F/YR20/0824/F

Demolition of rear annexe and workshop and alterations and refurbishment of existing dwelling to form a 4-bed dwelling

F/YR20/0854/F

Erect 3 x 2-storey dwellings comprising of 1 x 3-bed and 2 x 2-bed involving demolition of existing building within a Conservation Area

Date	Scale	Dwn	Dwg. No.	Rev.
June.2020	1:100/250	PD	LC.775.P101	B

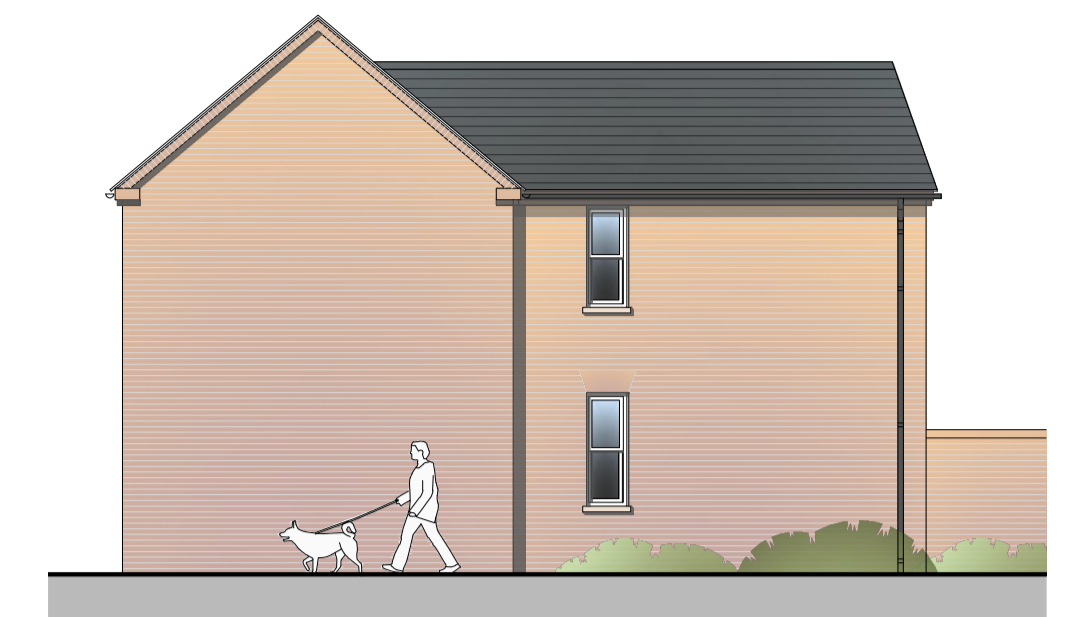
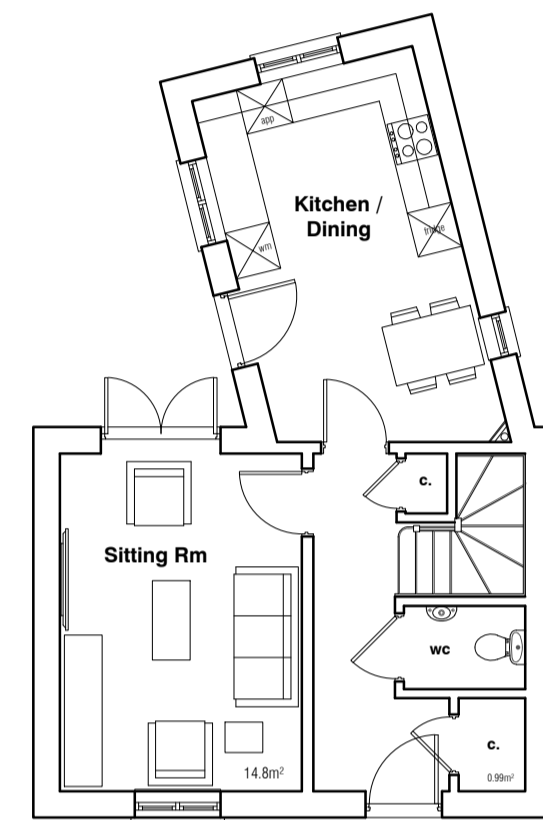
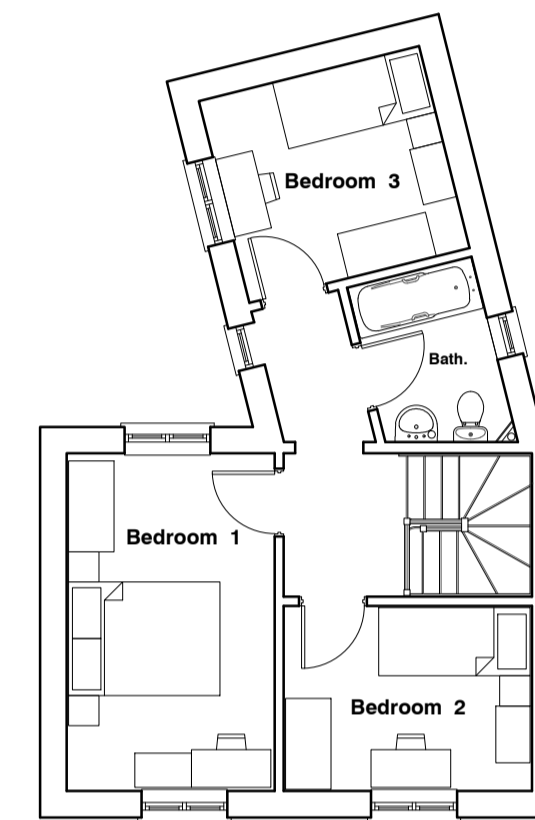
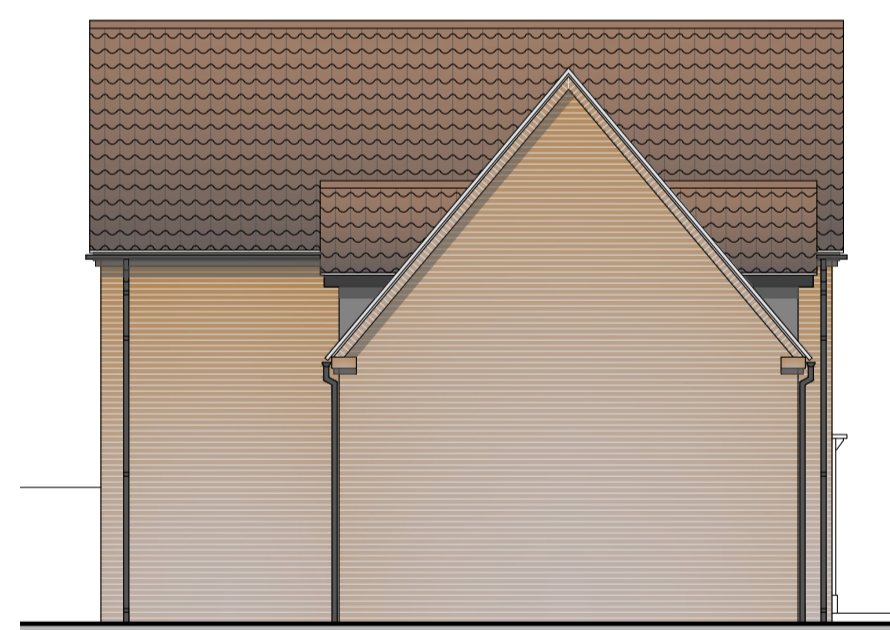
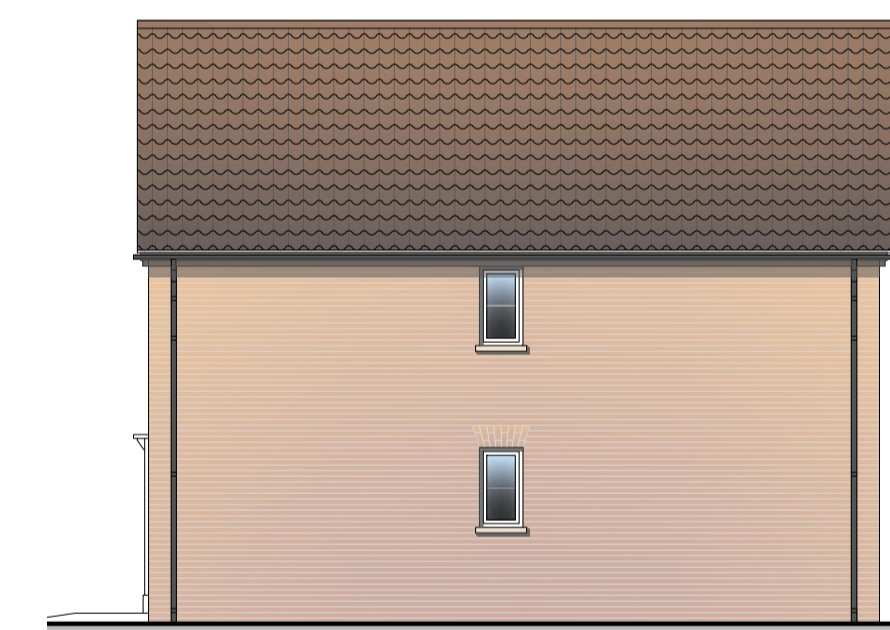
- 9.16 The proposal seeks to create a new dwelling to the front of Victoria Street, set back behind an enclosure. The Design and Access Statement (DAS) submitted indicates this would be hedging, but a low boundary wall would be more in keeping with the street scene and neighbouring properties. Again, the DAS presents an indicative photograph of a nearby historic property which Plot 1 (the street fronting property) would be designed to reflect. However, the proposed elevation drawings indicate an incongruously modern building, without symmetry or architectural detailing including first floor lintels, brick banding (not common, but present along Victoria Street) or a bay window and a poorly chosen style of door.

Plot 2 & 3

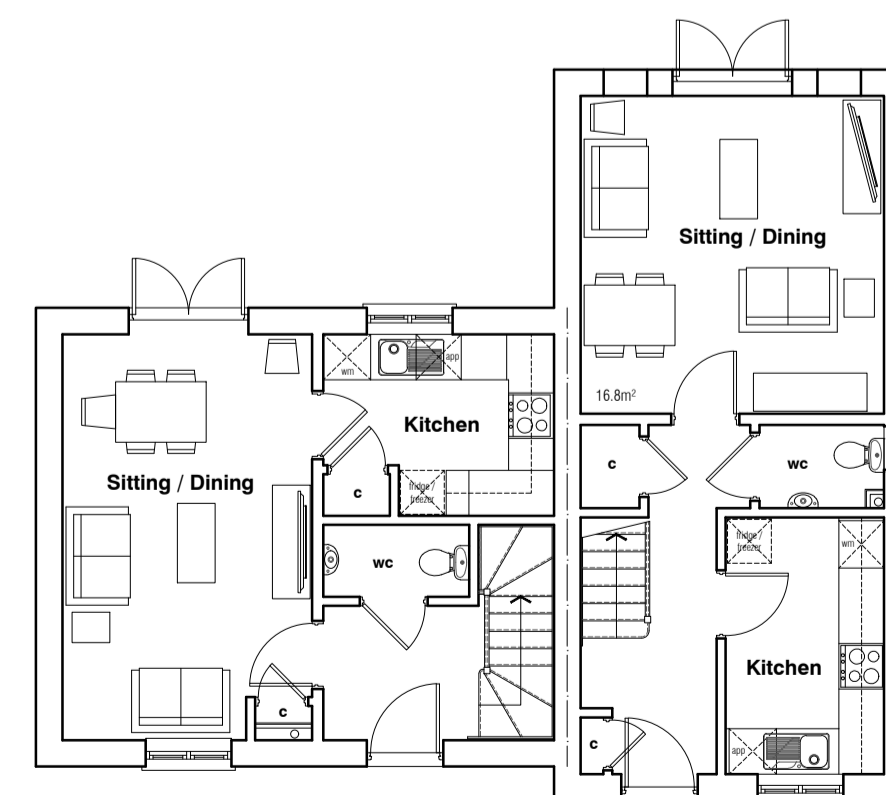
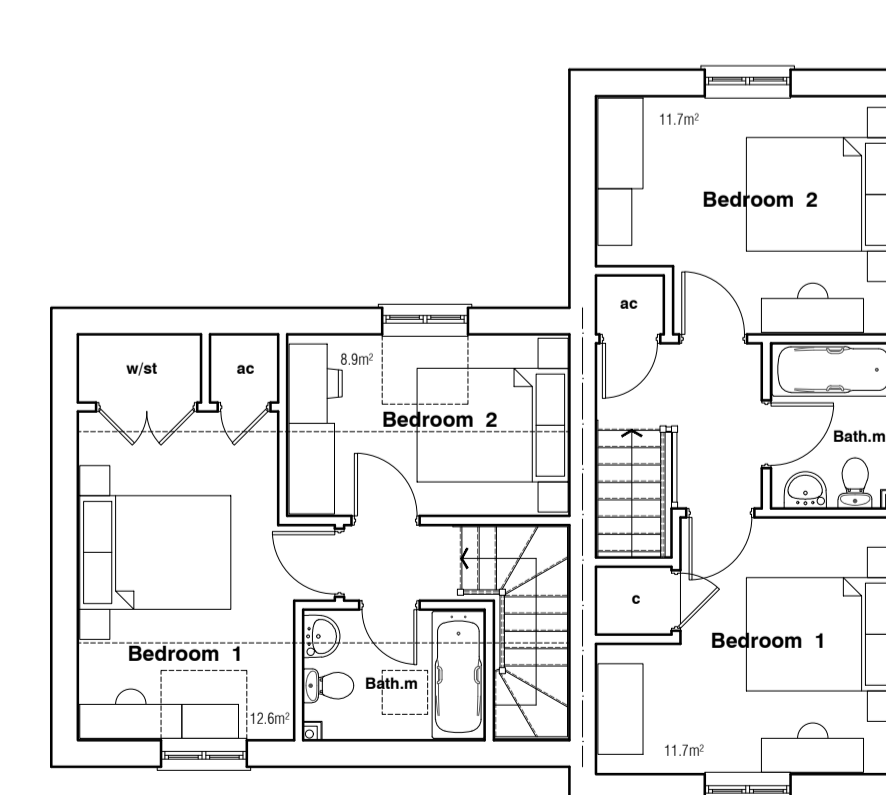
- 9.17 The proposal for Plots 2 and 3, have not altogether moved away from the parallel development that was put forward in the 2017 pre-app and advised against. There is simply a reduction in the number of plots. Plot 3 would therefore be visible as a residential dwelling set back from the street scene and out of character with the linear, burgage development and typical layout of rear workshops in these plots which were once common throughout the conservation area. That visibility along the length of the plot, which can often be glimpsed where these plots survive, would therefore be lost to the detriment of the character and appearance of the conservation area. It is also proposed that these plots will have tiled roofs in order to present a more vernacular character, and yet, while this is a characteristic of single storey workshops and sheds in rear plots elsewhere in the conservation area, slate is the predominant material in Victoria Street. However, on its own the use of the proposed roofing materials would not be sufficient reason to refuse the application

- 9.21 It is noted that the large tree in the adjacent garden is not shown on the plans (No 20 Park Street). This is likely to overshadow the small north facing rear garden to Plot 2 providing a poor quality of private amenity space. It is also noted that the first floor rear window to Plot 3 is only 8m from the boundary with No 16 Park Street, increasing the potential for overlooking. However, it is noted that this area is not included in either application, so clarification is required. More detail is also required to understand the type and level of private amenity space which is to be retained with No 16 following the subdivision of the site. Notwithstanding this, these concerns on their own would not be sufficient to warrant a refusal.
